MODIFICATION RECOMMENDED

N9918A-01

S E R V I C E N O T E

N9918A - FieldFox Handheld Analyzer

Figure 1: No sidebands issue

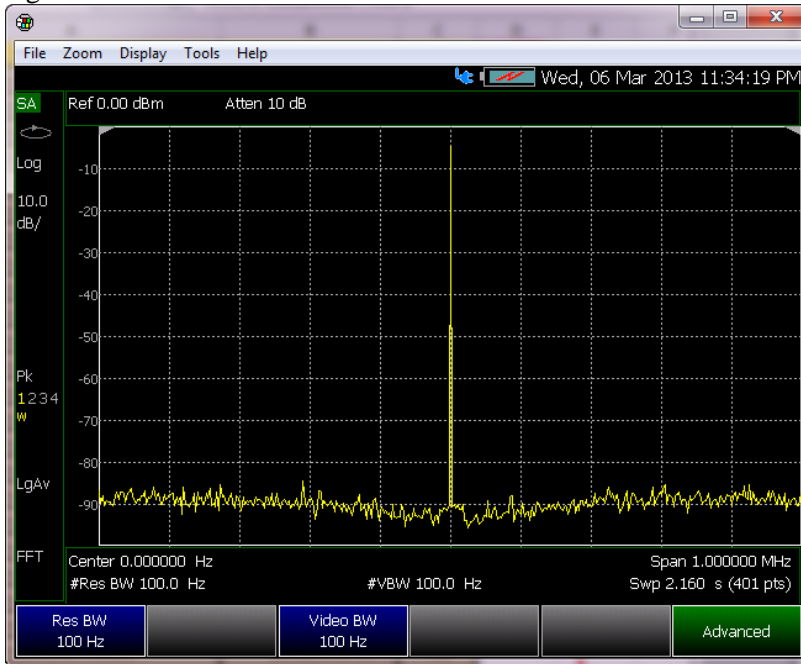
RF board earlier than Rev 7 may have sidebands issue due to oscillation by the voltage regulator. After it is fixed by replacing a new inductor, the RF board revision header will be updated to reflect the change.

Figure 1 shows a good RF signal, and Figure 2 shows FieldFox with sidebands issue.

Affected FieldFox are required to send back to Agilent factory for RF board reliability enhancement. The RF board revision header will be updated to reflect the change. Test and Adjustment shall be done before shipping back to customer.
